29 June 2022
Ref 21315

**PROPOSED RESIDENTIAL DEVELOPMENT
30 FAIRLIGHT STREET, FAIRLIGHT
TRAFFIC AND PARKING ASSESSMENT REPORT**

Project Name	30 Fairlight St, Fairlight	Project Number	00012781
Project Address	30 Fairlight St, Fairlight, NSW 2094	Drawing Name	Basement Plan
Client	Adjani Pty Ltd	Scale	1:150 (A3)
		Date	June 2021
Drawing Number	DA200	Revision	E

FIGURE 3.3 MINIMUM SIGHT LINES FOR PEDESTRIAN SAFETY

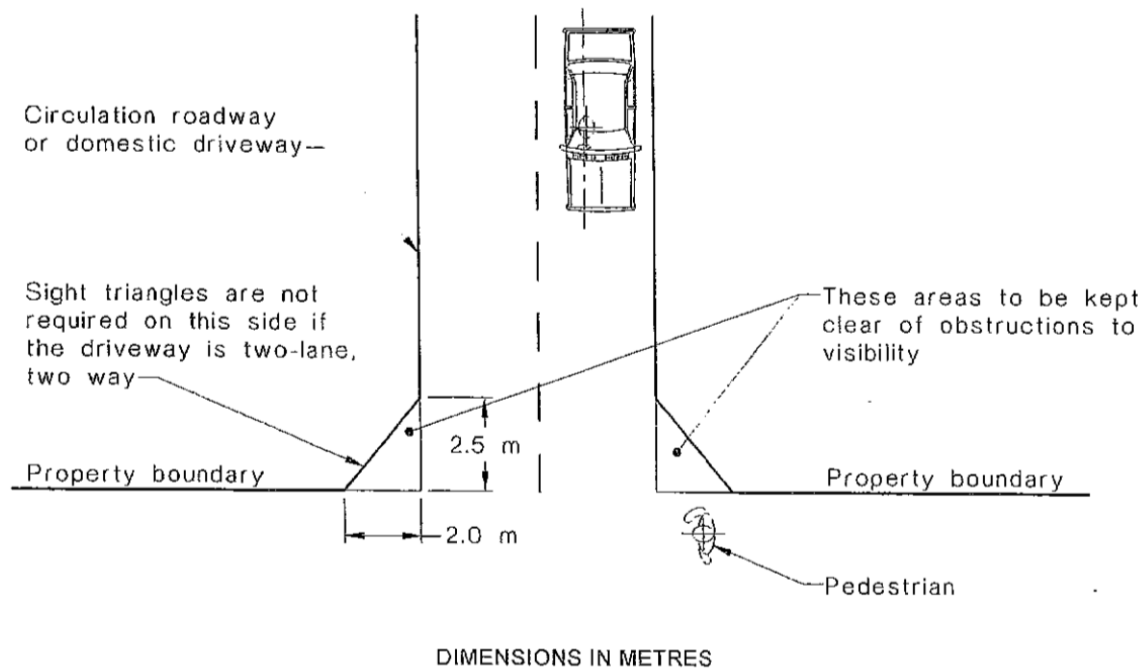
- the width of the car park aisle within the site is 6.1m, which is sufficient to allow an exiting vehicle to wait within the car park to give priority to an entering vehicle
- a sign should be mounted within the car park adjacent to the garage door, stating "Give Way to entering vehicles at all times"
- the parking bay and aisle width dimensions provided on the plans comply with the requirements of *AS2090.1-2004*, and
- the landscaped areas proposed outside the garage door are sufficient to accommodate the visibility space on both sides of the driveway in accordance with Figure 3.3, Minimum Sight Lines for Pedestrian Safety, as per *AS2090.1-2004*, provided that the height of the mature plantings within the displays do not exceed 900mm in height above the driveway surface.
